## Appendix 9.1 Email Consultation with OIC Environmental Health

**Agreement of baseline noise monitoring locations:**

**Subject:** Faray Wind Farm - Noise baseline survey approach and method

**Figure 1 - overview of study area**

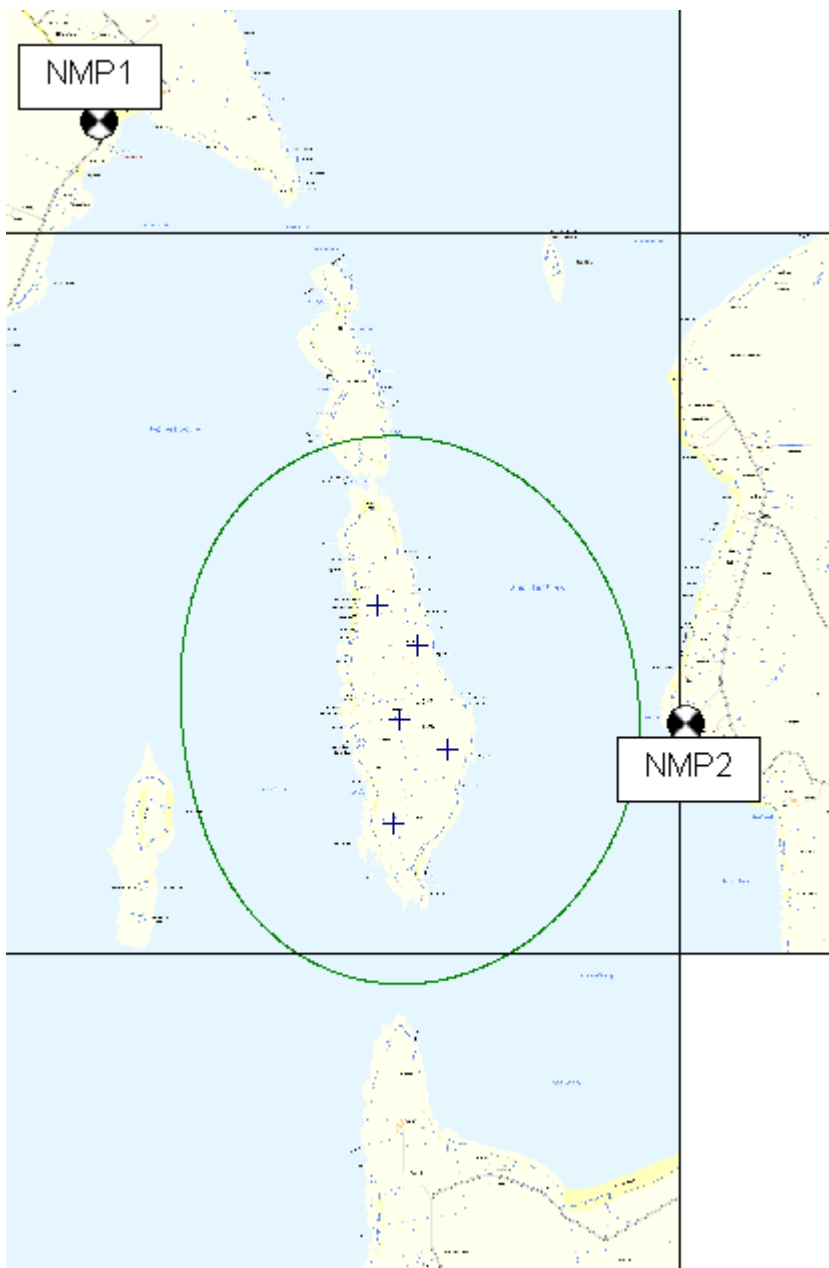
I provide in Figure 1 a screenshot showing the 35dB contour given the current proposed layout (note that layout and turbine model used may be subject to change), with ground absorption set to G=0.

As shown in Figure 1, Fers Ness on Eday is directly to the south of Faray and close to the 35 dB contour, however, this promontory is likely to be somewhat exposed, and therefore noise from the sea is likely to be higher than at locations to the east of Faray. We therefore propose to monitor at a location on the western side of Eday, as shown in Figure 3.

Why do background noise measurements at all if modelling indicates compliance with flat 35dB LA90? - Just a comment / suggestion, I guess background noise measurements now keeps the options for position of turbines / size of development open.

Ferness - I would suggest you think again about having a (third) NMP in this area, perhaps not at Ferness itself as there is a small WTG to the north. If the proposed turbines are moved further south than currently indicated Ferness may become a more sensitive receptor - are you happy to use proposed NMP2 as basis for Ferness area noise limits?

Figure 2 - Westray – NMP1

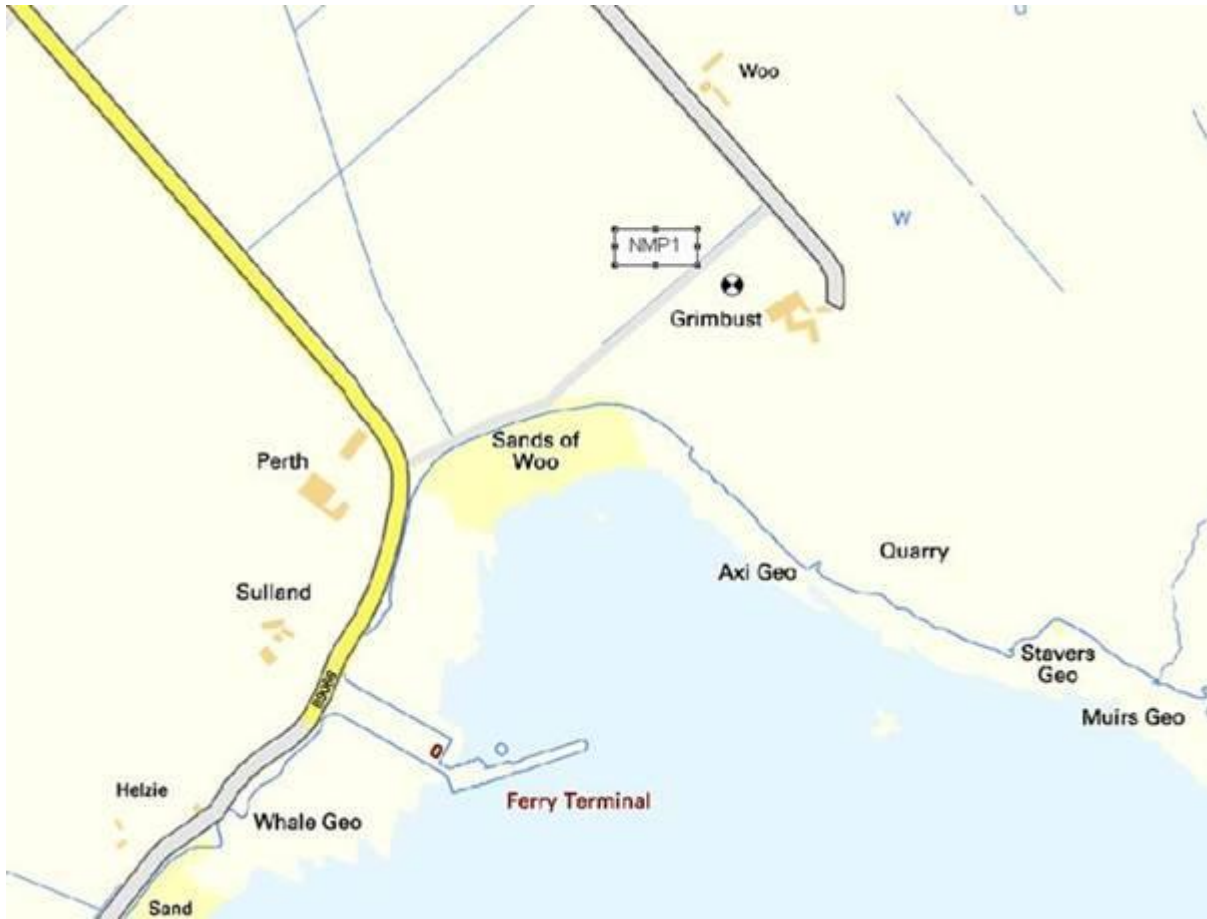
**NMP1** will be sited on Westray, likely at a property close to the ferry terminal, making sure to avoid any audible plant. We anticipate that ferries will be infrequent, and predominantly/entirely during the daytime period. Any noise from ferries during weekend daytimes will be identified in data processing and removed from the dataset, with excluded data shown on the noise limit derivation charts. The proposed location is shown in greater detail in Figure 2.

No objection to suggestion re Westray NMP, there are number of small WTG to north of Grimbust, you may need to directional filter the data or perhaps consider a NMP to west of ferry terminal where, from memory, there are fewer domestic WTG's.
